UNITED STATES PATENT AND TRADEMARK OFFICE

Office Action Summary

09/983,047

DETAILED ACTION

Figure 3a - U.S. Patent 6,218,661 to Schroeder et al., filed 10.16.98

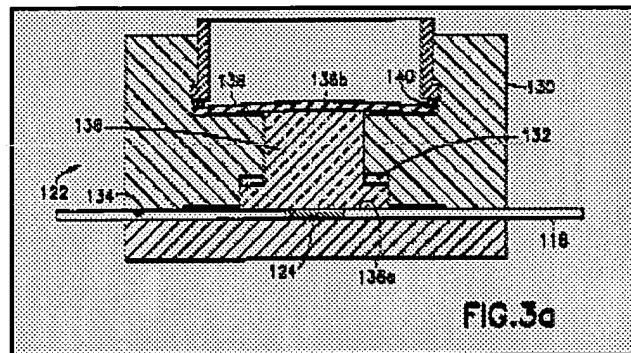
2. As per claim 1, 11 and 13, Schroeder et al. disclose an apparatus comprising at least one optical fiber (118) (see also Fig. 4 – not shown above – 234, 235) supported in a structure (130); a movable mass (136) supported within the structure (130) and means (Fig. 1, not shown above; i.e. 12, 14, 16, 18, 20, 22, 24, 26) for detecting changes in tension in the at least one optical fiber due to movement of the movable mass (132) – (see abstract, Figs. 1-3).

3. As per claim 2, Schroeder et al. disclose an apparatus wherein the detecting means comprise at least one fiber optic Bragg grating (Fig. 3, 124) written into a core of each of said optical fibers.

5. As per claims 8 and 9, Schroeder et al. disclose an apparatus wherein the structure comprises a cage (Fig. 3 above) and wherein a gap is provided between each side of the mass and cage; the gap being sufficiently small to limit motion of the mass in shock or high acceleration and to limit the maximum tension seen by each of the optical fibers.
